### APPEAL SUMMARY

<b>Appeal ID:</b> 27632	<b>Project Address:</b> 5010 SE Woodstock
<b>Hearing Date:</b> 3/30/22	<b>Appellant Name:</b> Melissa Meiners
<b>Case No.:</b> B-014	<b>Appellant Phone:</b> 5037082157
<b>Appeal Type:</b> Building	<b>Plans Examiner/Inspector:</b> John Cooley
<b>Project Type:</b> commercial	<b>Stories:</b> 4 <b>Occupancy:</b> A-2, B, R-2 <b>Construction Type:</b> III-A
<b>Building/Business Name:</b>	<b>Fire Sprinklers:</b> Yes - Throughout
<b>Appeal Involves:</b> Erection of a new structure	<b>LUR or Permit Application No.:</b> 21-113246-CO
<b>Plan Submitted Option:</b> pdf [File 1] [File 2]	<b>Proposed use:</b> Apartments, Coffee Shop

Woodstock Mixed-Use

APPEAL ITEM 1

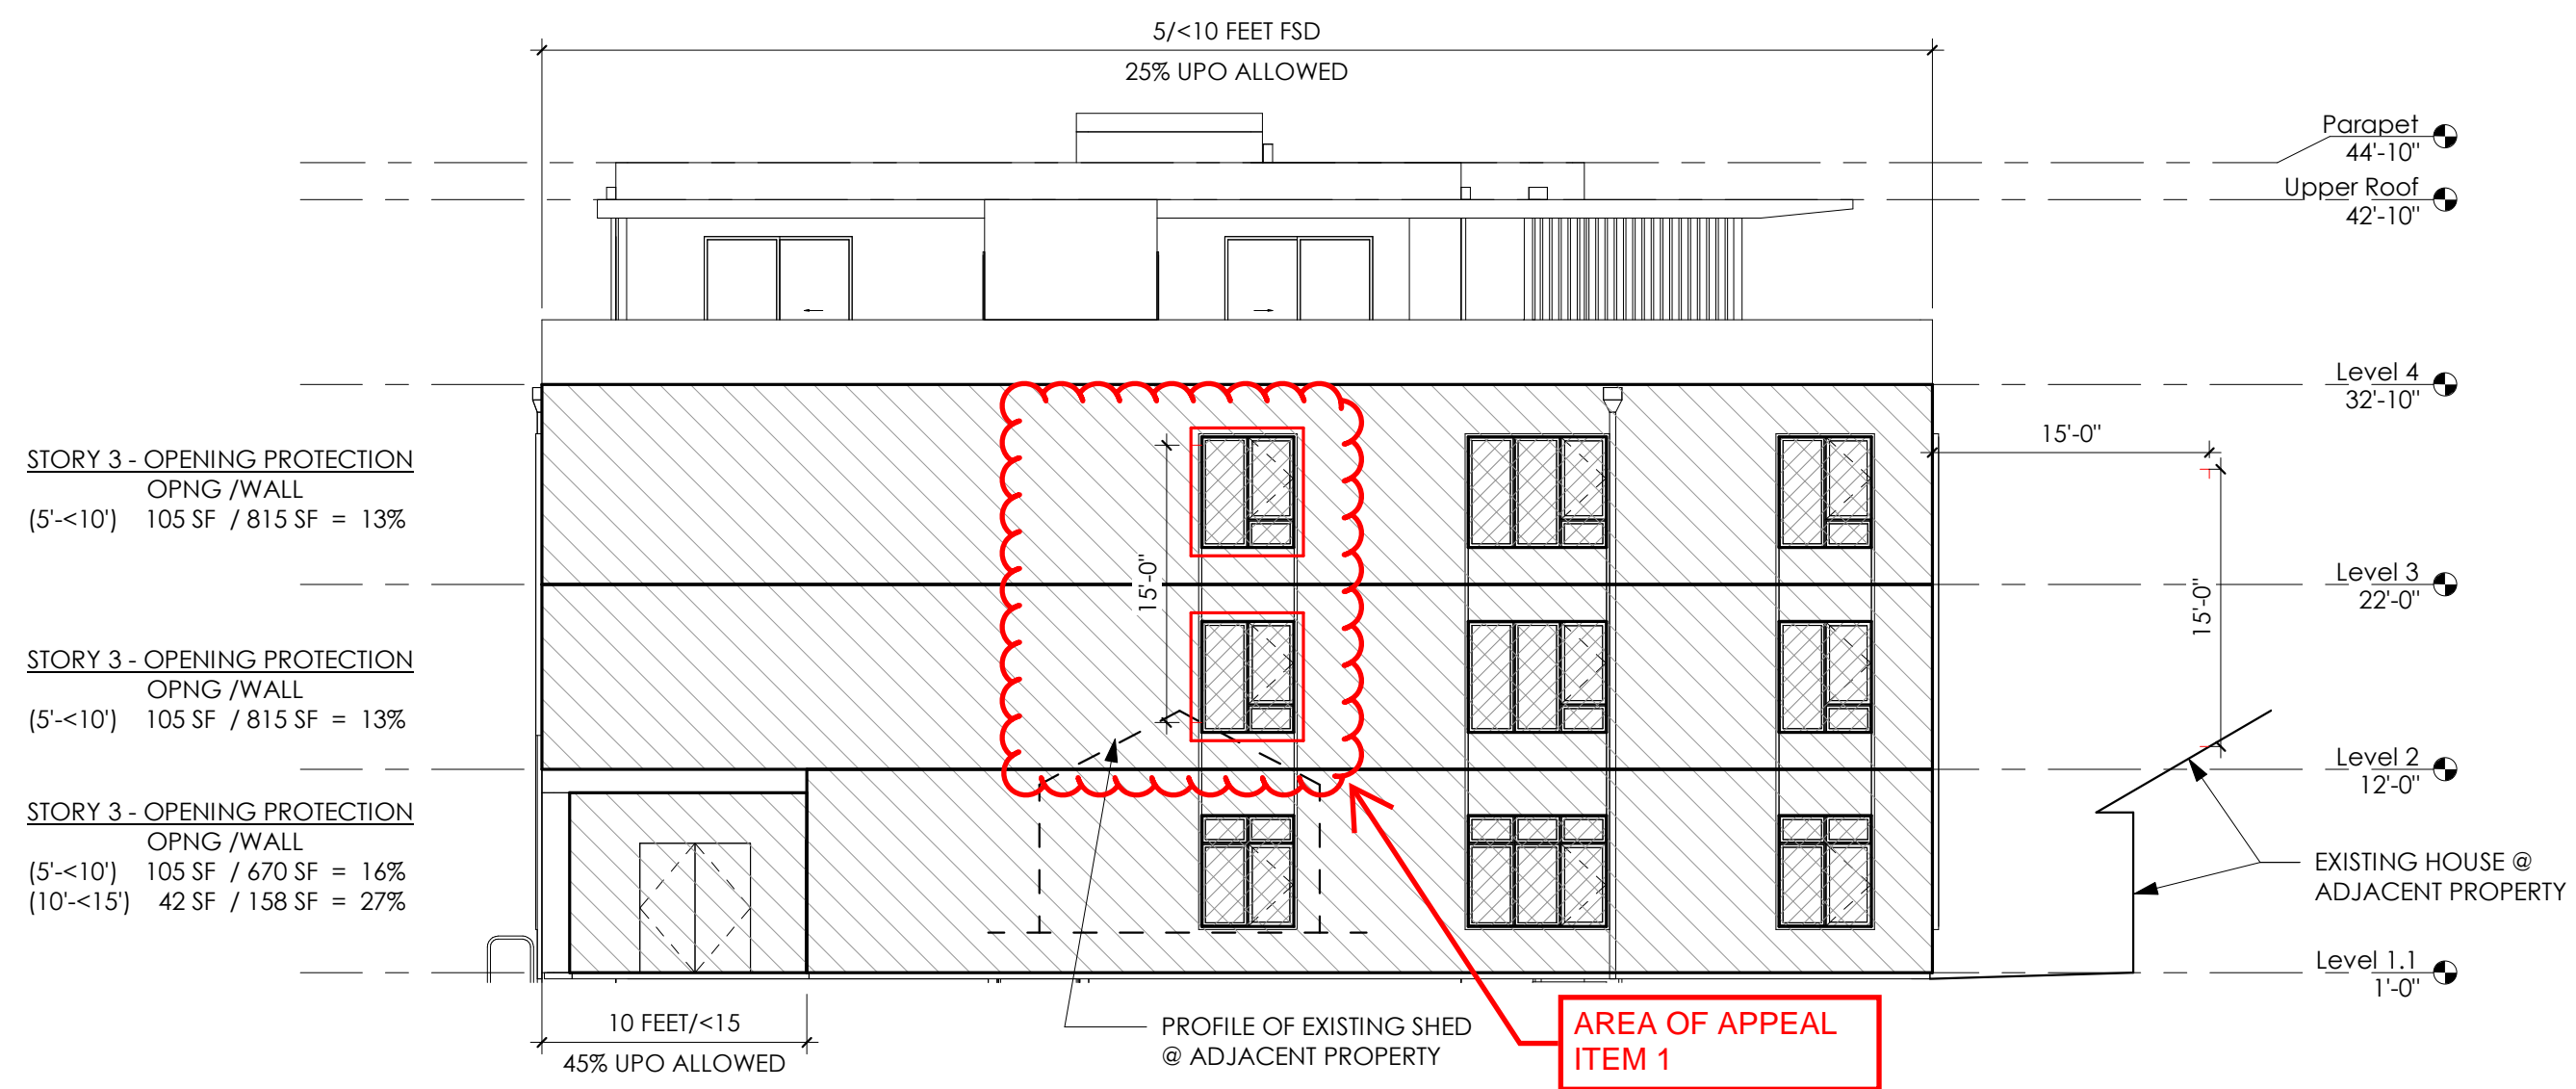
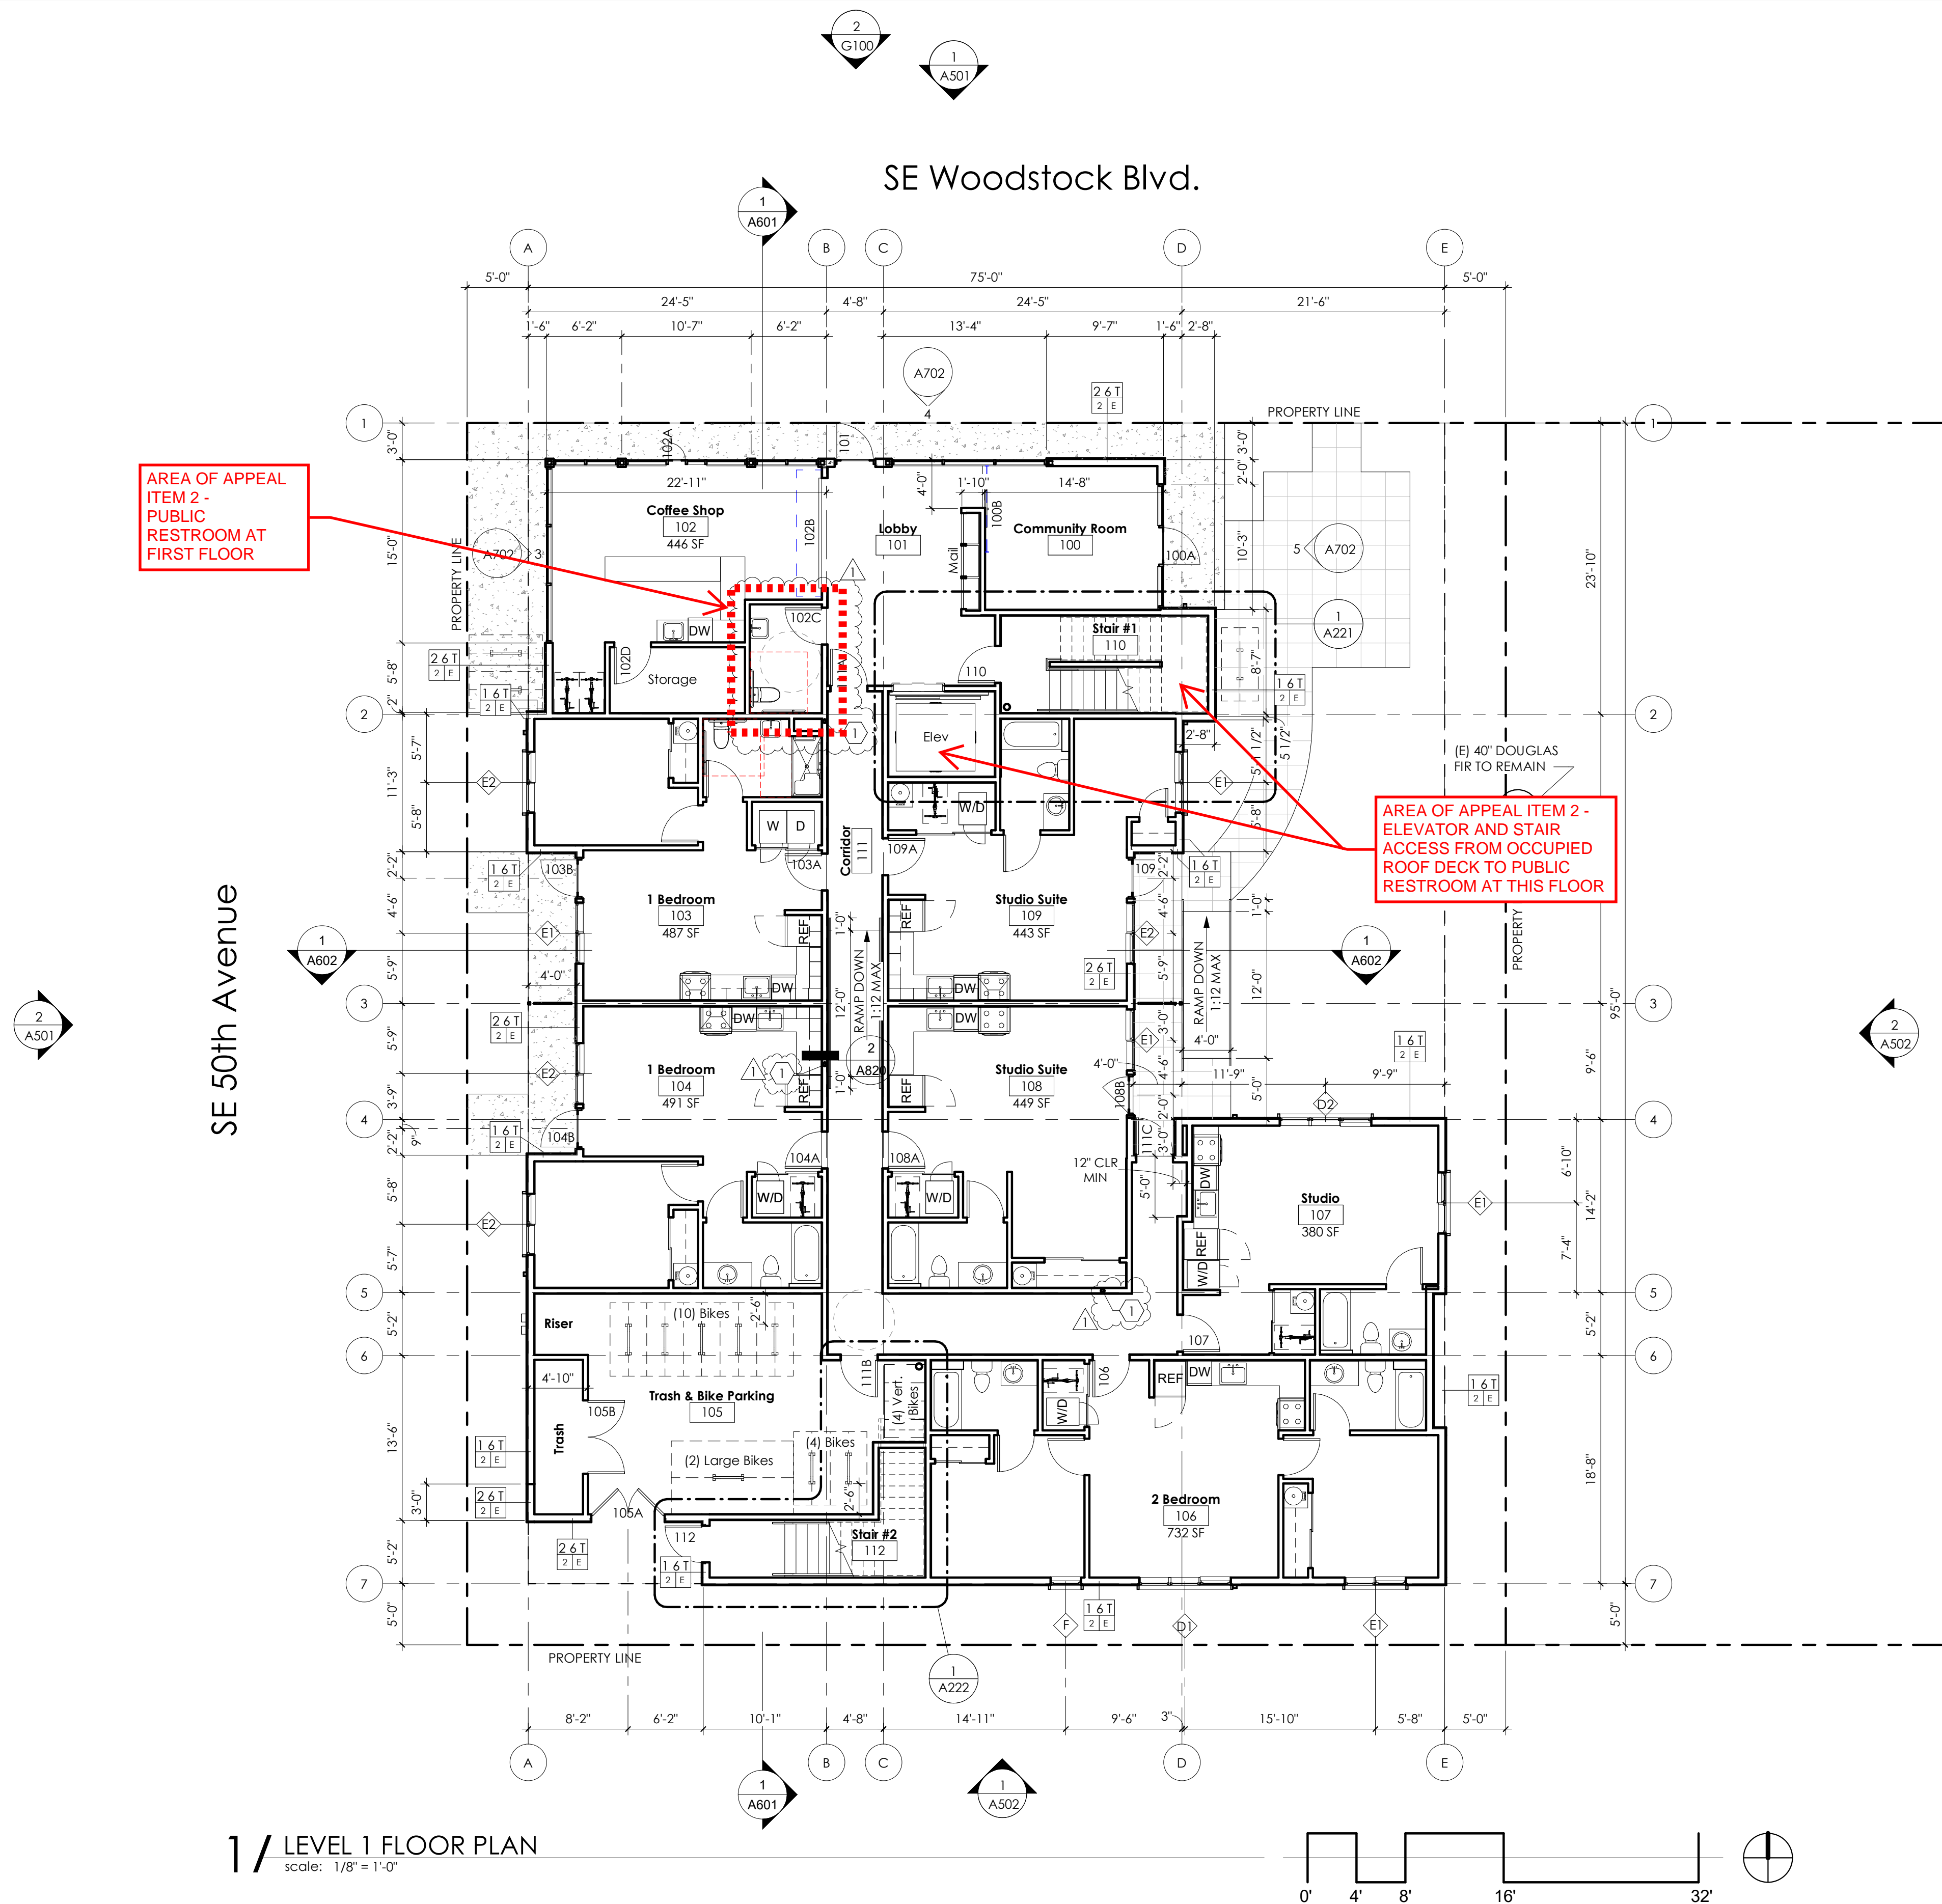
<b>Code Section</b>	705.8.6.2
<b>Requires</b>	Where a new building is to be erected to an adjacent building, all opening protectives in the exterior wall of the new building are required to have a fire protection rating of not less than 3/4 hour where these opening protectives are less than 15 feet vertically above the roof of the existing building or structure.
<b>Code Modification or Alternate Requested</b>	Allow sprinkler protection of exposed, unrated windows.
<b>Proposed Design</b>	Building is fully sprinklered per NFPA 13. (2) windows on the 2nd and 3rd floors at the south elevation and (2) windows on the 2nd and 3rd floors at the East elevation are exposed less than 15 feet vertically above the roof of adjacent structures on separate lot.
<b>Reason for alternative</b>	Provide equivalent protection of unrated windows with sprinkler protection where windows are located within 15 feet vertically above the roof on adjacent lot. Similar appeals have been granted, reference Appeal ID 27530

**1. Type 13 water curtain sprinkler protection at non-fire rated openings in buildings with vertical exposure on separate lots: Granted provided windows are non-operable and sprinklers are spaced not more than 6 feet apart and placed a minimum of 6 inches and a maximum of 12 inches from the opening(s) and a maximum of 12 inches below the ceiling. Sprinklers are to be installed on the occupied side of the openings. A separate permit from the Fire Marshal's Office is required.**

**Note; Fire damper protection of mechanical vent openings may be prescriptively used but no dryer vents PTAC units or eave vents may be located within appeal area.**

APPEAL ITEM 2

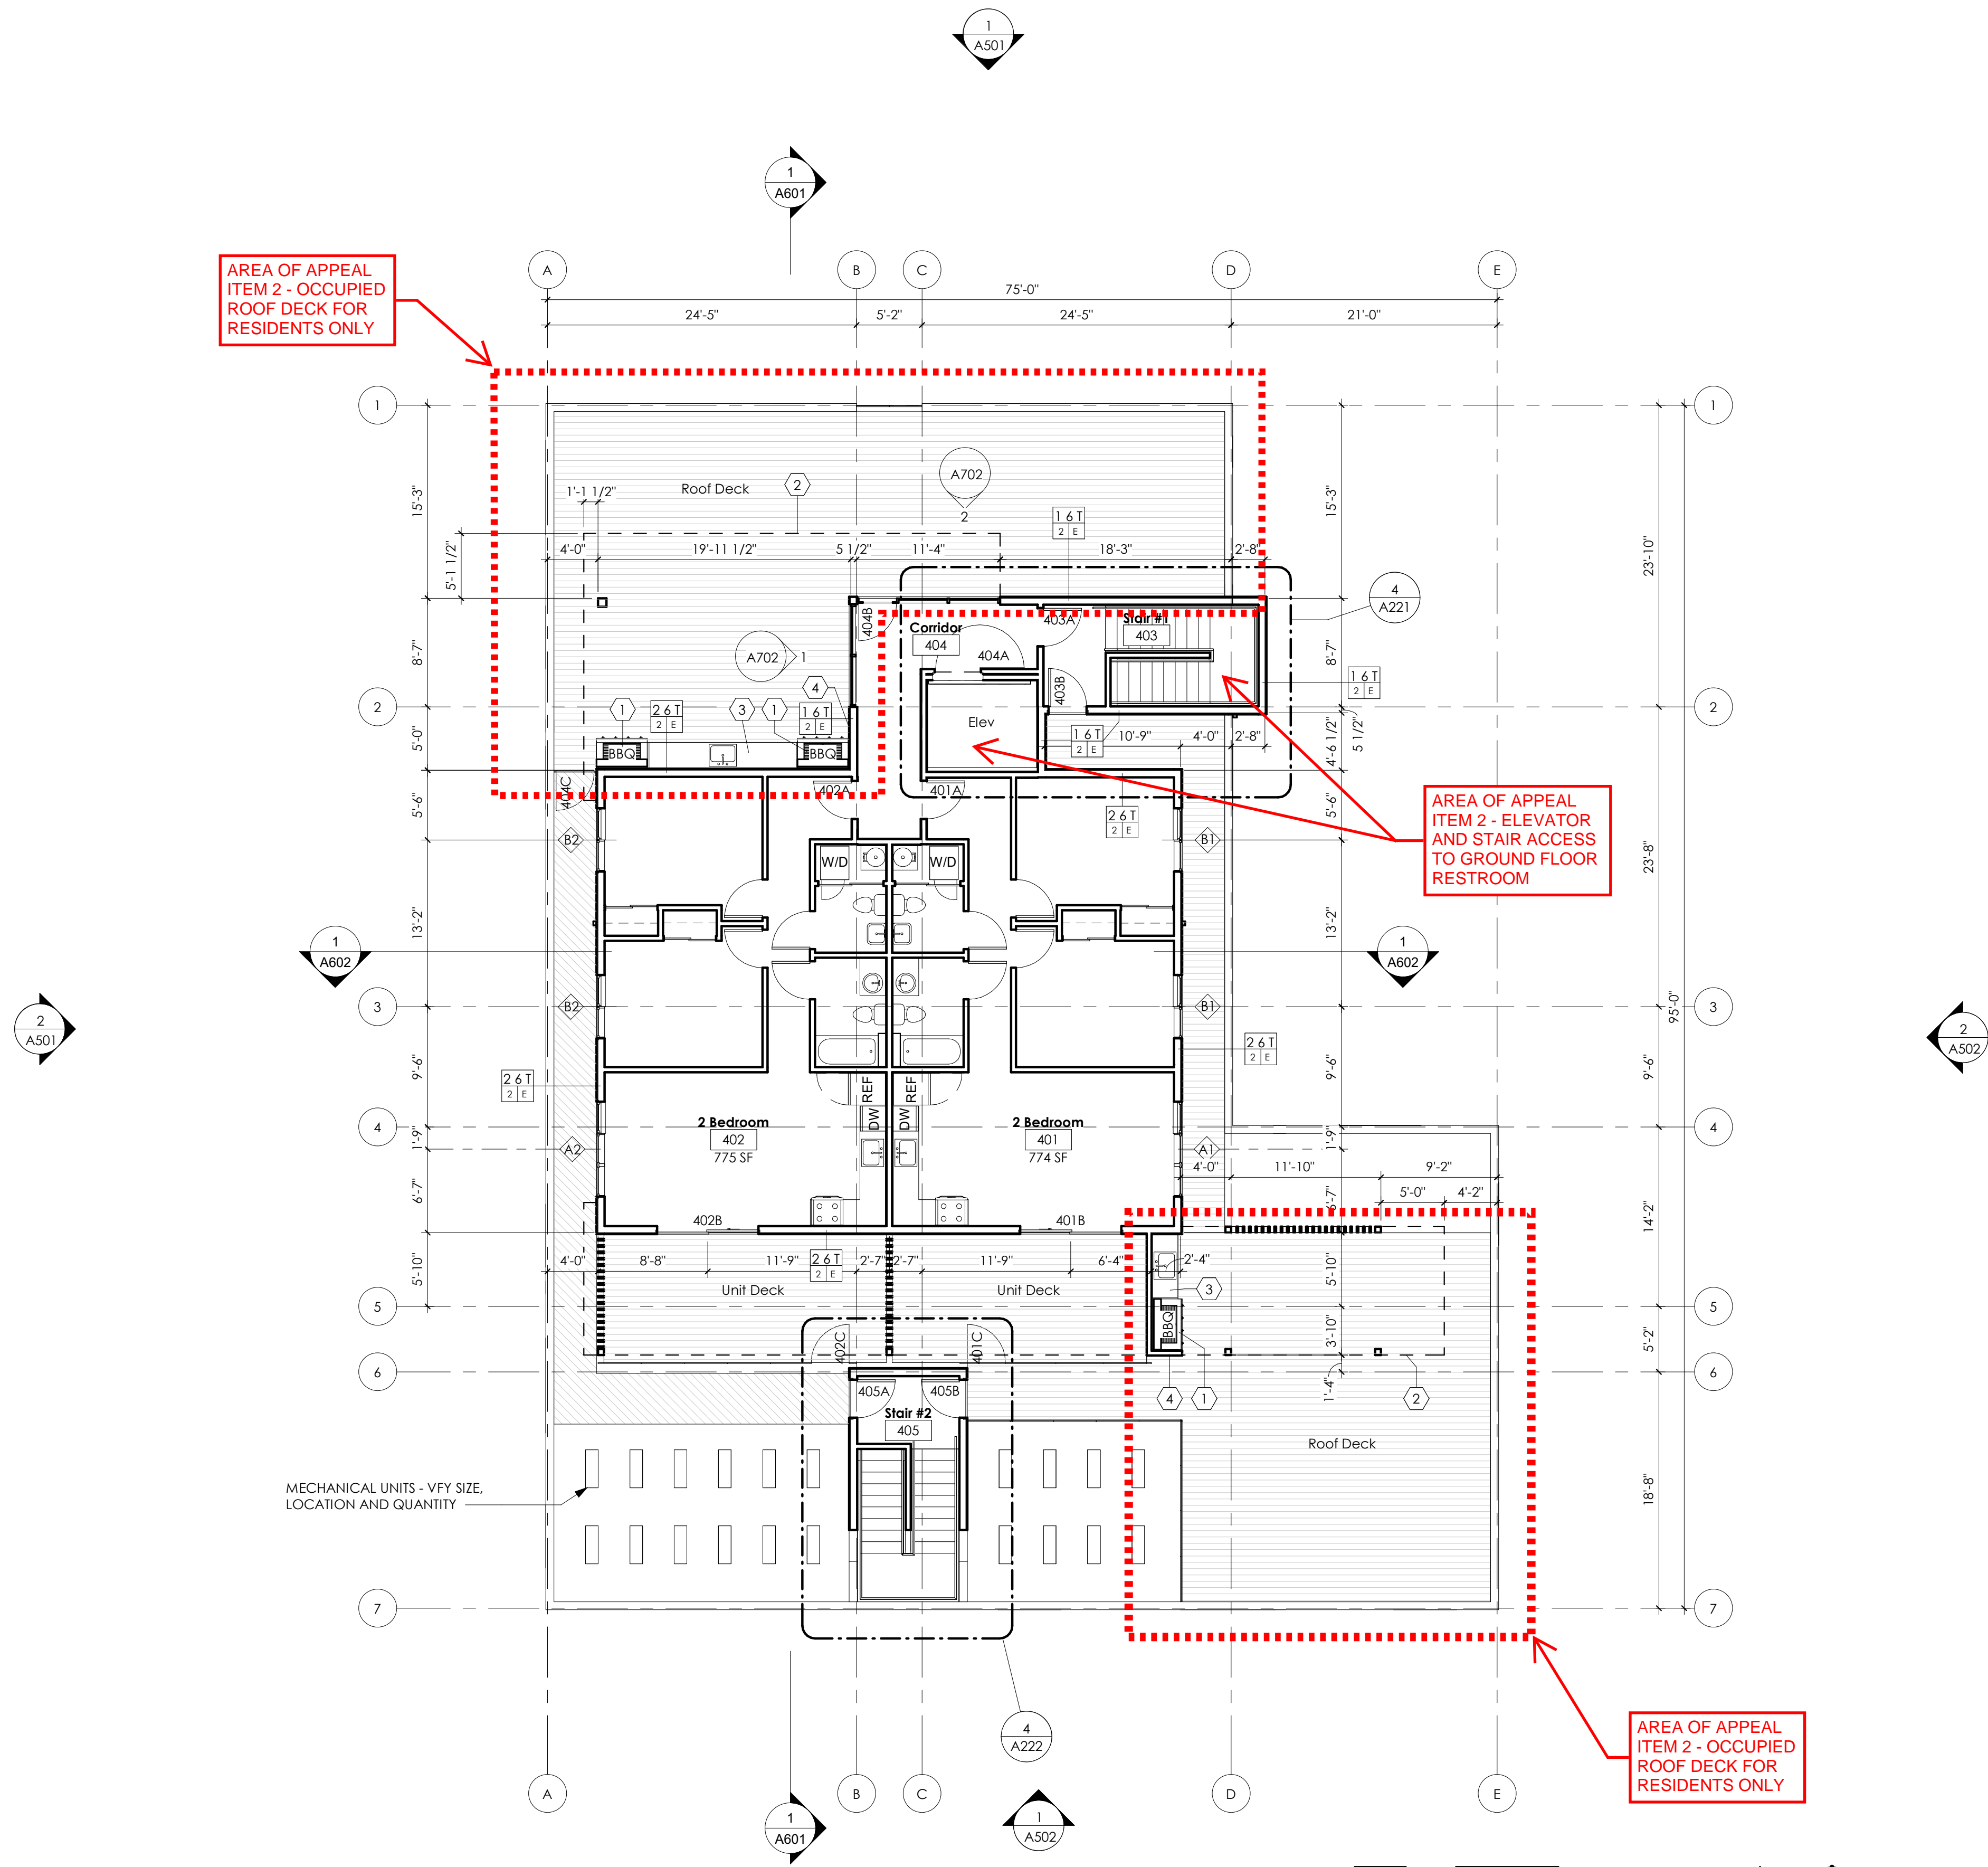
<b>Code Section</b>	2902.3.3
<b>Requires</b>	In occupancies other than covered and open mall buildings, the required public and employee toilet facilities shall not be located more than one story above or below the space required to be provided with toilet facilities.
<b>Code Modification or</b>	Allow toilet facilities in individual dwelling units and the unisex toilet at the ground floor to fulfill the

**Alternate Requested** requirement for toilet facilities that serve the occupied roof deck for residents' use only.

**Proposed Design** The occupied roof decks are located on the 4th story, along with other dwelling units. The roof decks are for residents' use only and their guests, who have access to toilet facilities within their individual dwelling units located on this same story or stories below. They also have access to a single public toilet located on the ground floor and accessed via elevator or stairwell.

**Reason for alternative** The project exceeds the number of toilet facilities required per Chapter 29. The roof decks can be considered accessory to the main occupancy (R-2) as occupants and their guests are either occupying their individual dwelling units or occupying the outdoor deck space. And toilet facilities are provided for these occupants within dwelling units which they have direct access to via elevator or (2) stairwells, as well as a single public unisex restroom located directly off the elevator at the ground floor. Similar appeals have been granted, reference appeals 15184 & 26209.

**2. Reduction in the minimum number of required plumbing fixtures: Granted provided an additional toilet room is provided at the 3rd or 4th level to serve the roof deck per footnote "g" of 2022 OSSC.**
